State of Alaska
Department of Fish and Game
Habitat and Restoration Division

Nomination for Waters
Important to Anadromous Fish

Anadromous Water Catalog Number of Waterway 182-70-11400-2010 - 3071

Name of Waterway Seal Creek

SealCrkQ2X2.jpg

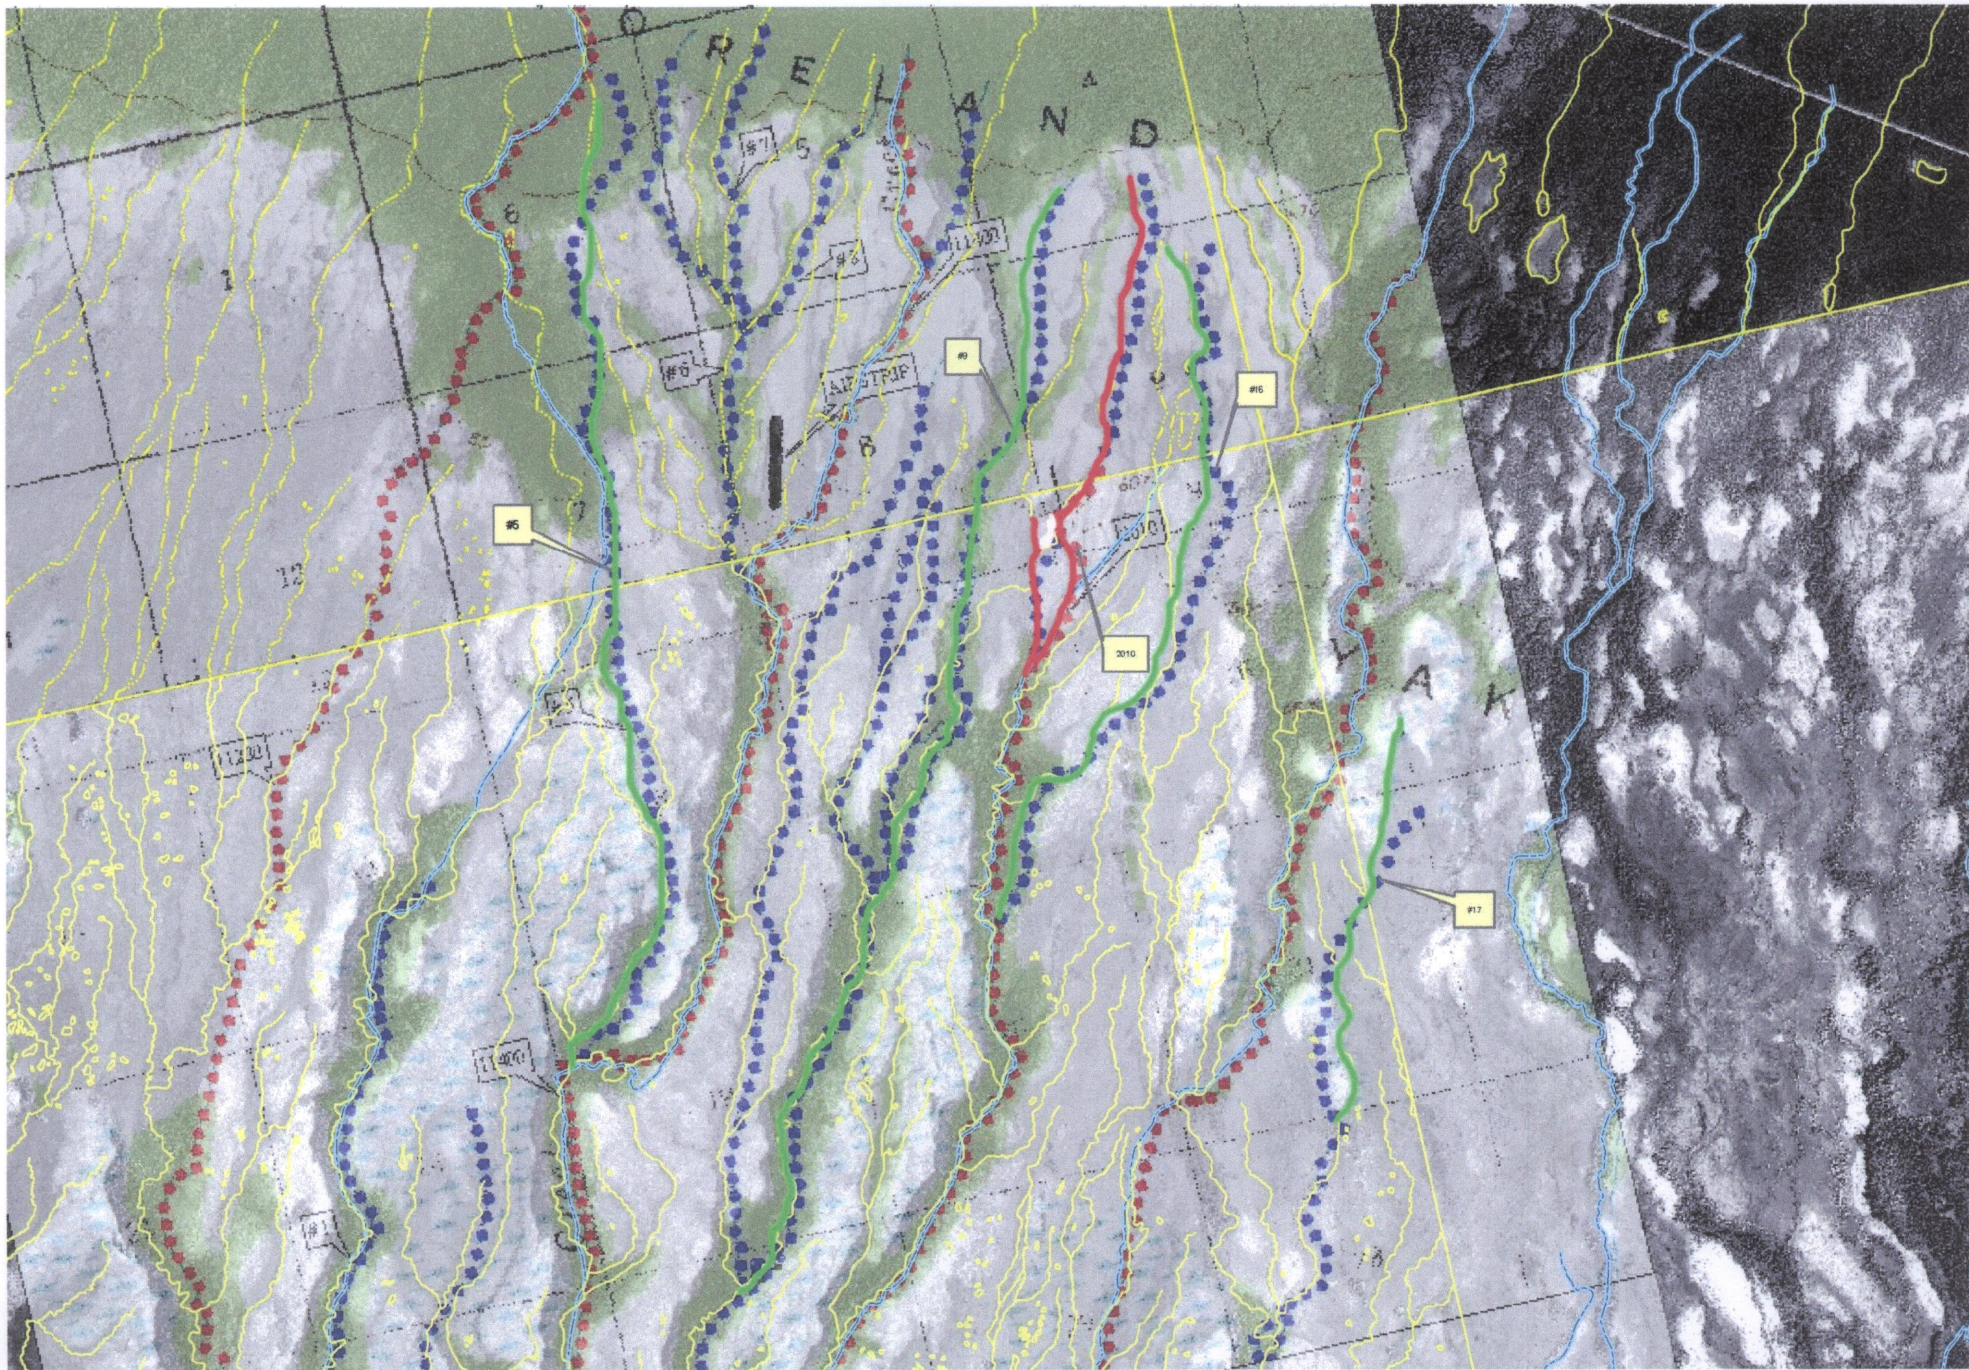
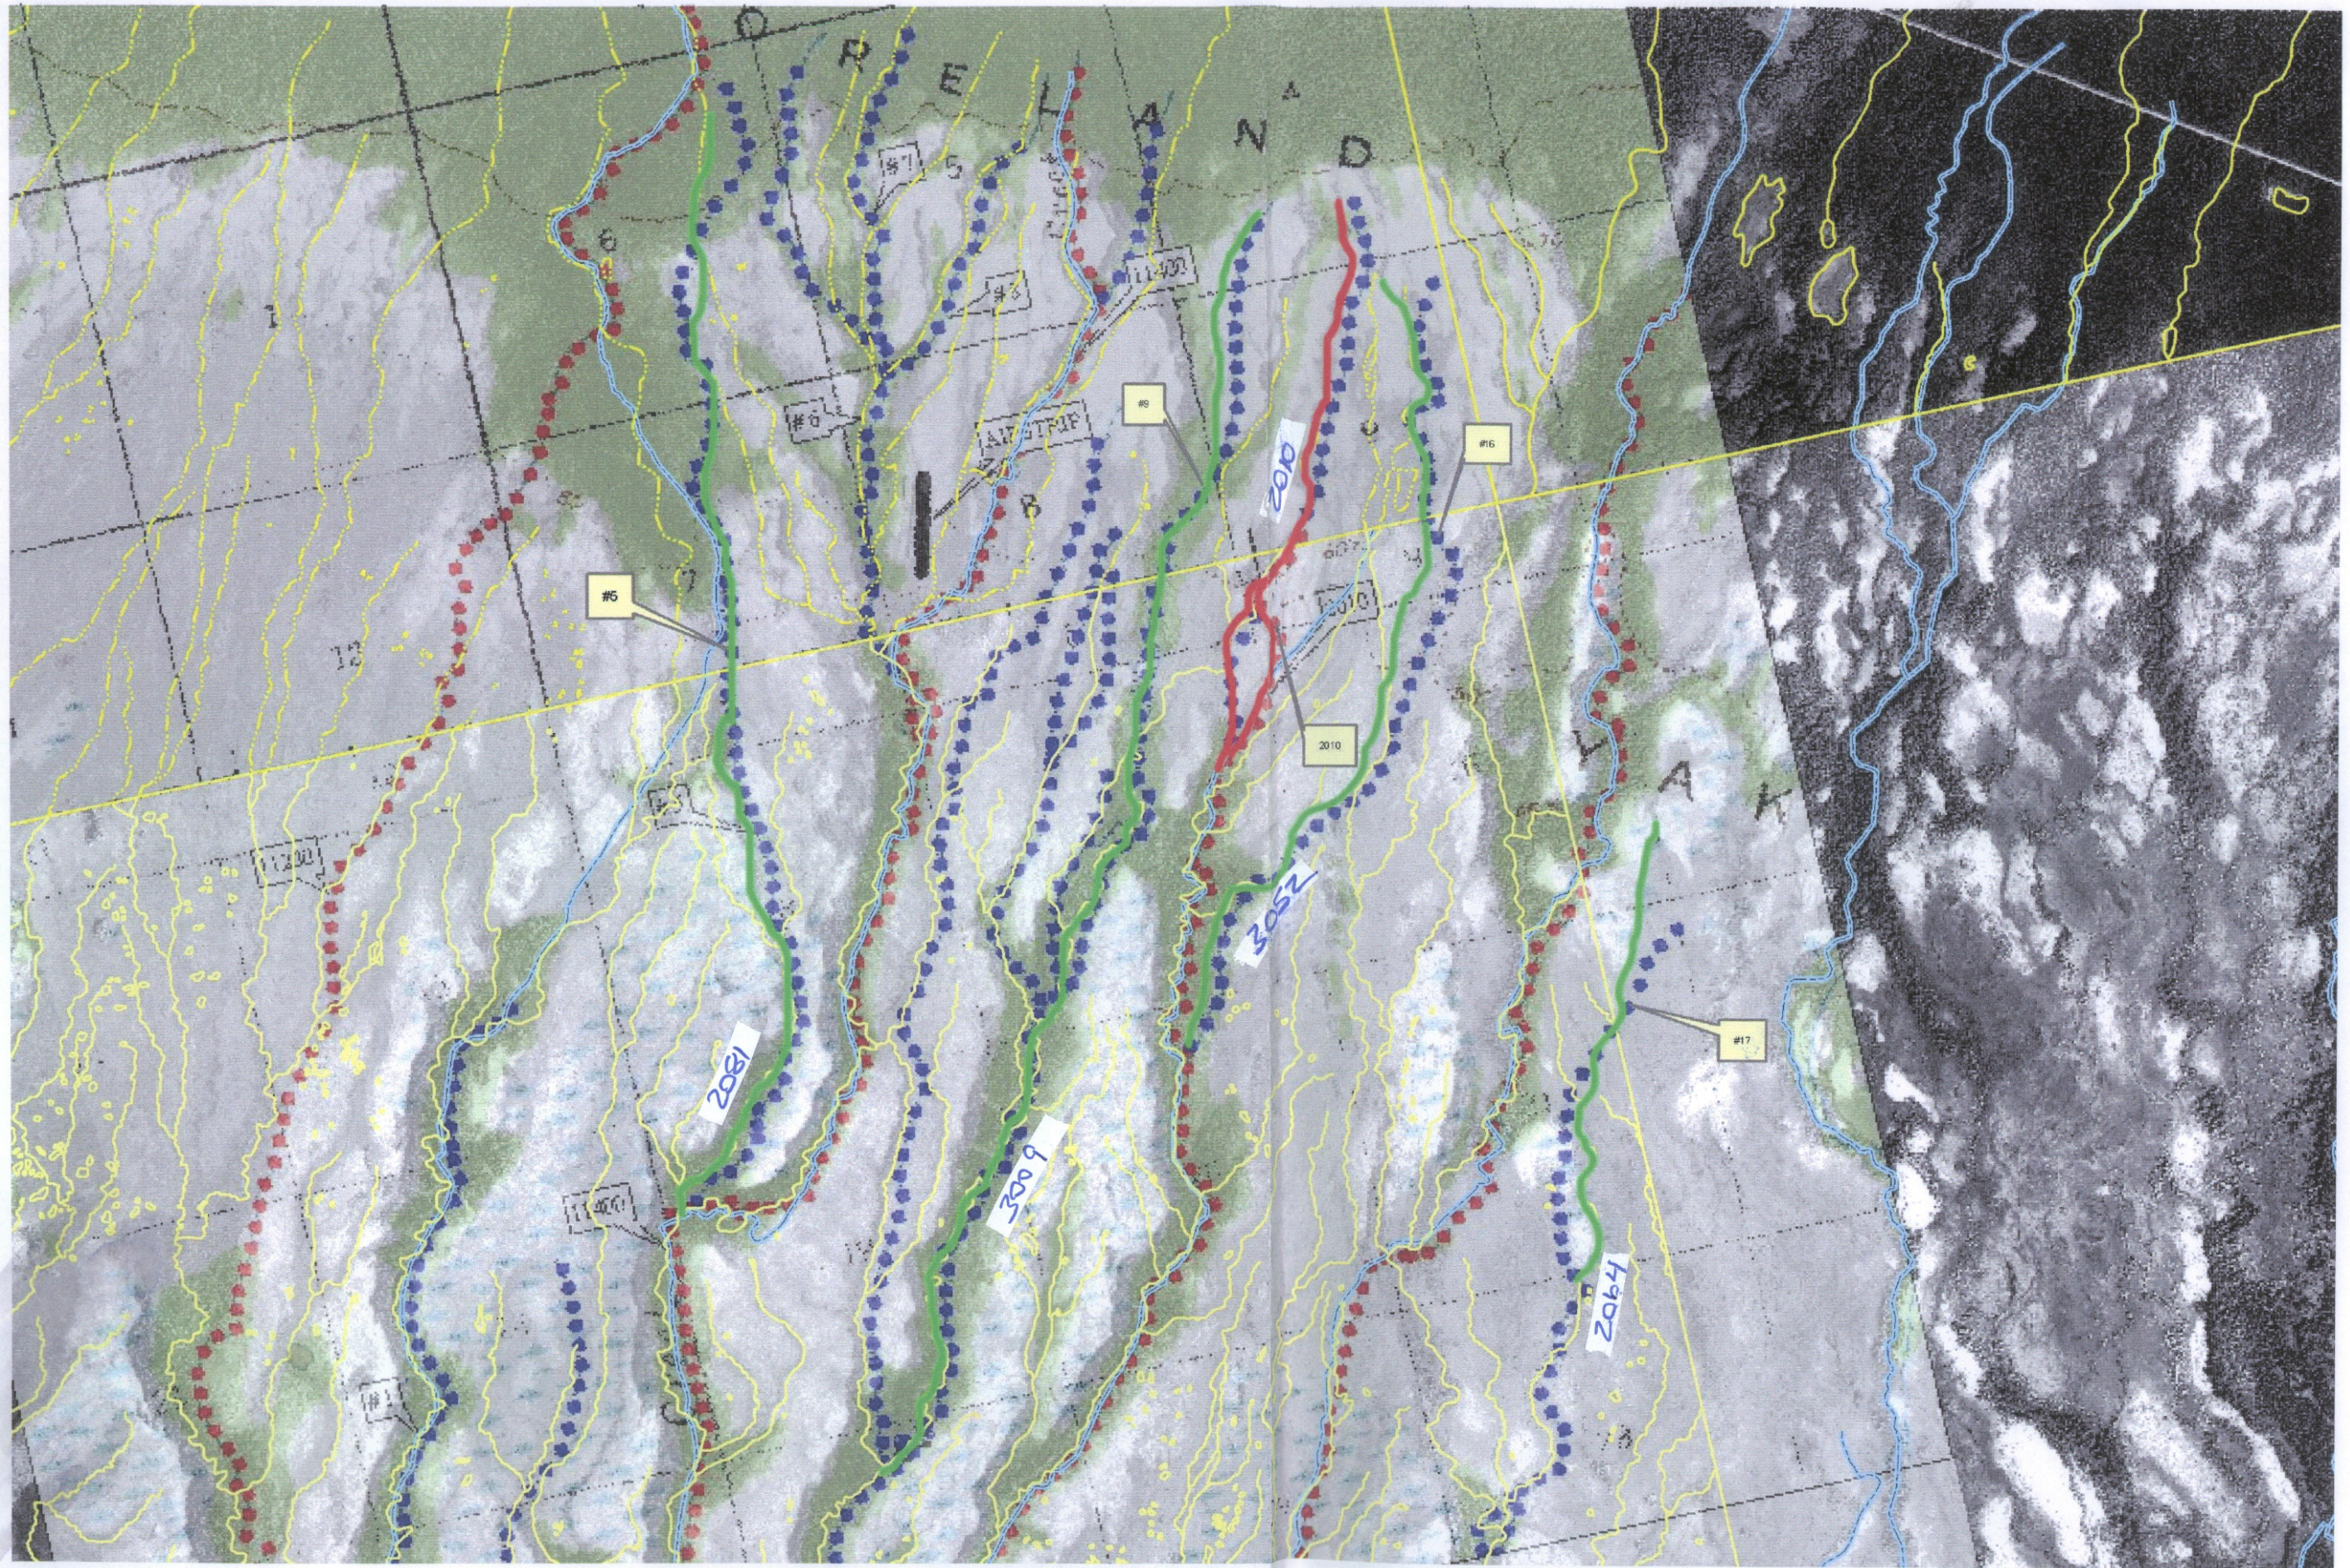
One final question on this. #15 appears to come from and then rejoin stream

2010. Is this the case (a distributary) or is it a separate stream that heads near the 2010 channel?

Looks like a few more of these are jumping between the different hydro streams that I have. Can you look at the attached Jpeg and let me know where the stream should lie for streams 5, 9, 16, 17 and there's also something going on there with the upper section of 2010. I've overlain your original submittal with the hydro and photo in the jpeg.

Nope - I screwed up. It's separate. It come close to but doesn't join up on the other end. In looking at your hydro it is probably the one just to the west. Look at this re-modification jpg and see if that helps. Phil

<< File: SealCrkQ2X.jpg >> Ed - here's the modified jpg for this. This was is pretty tough because of the beaver dam activity throughout this upper area re-routing water every-which-way. My best guess.... Phil
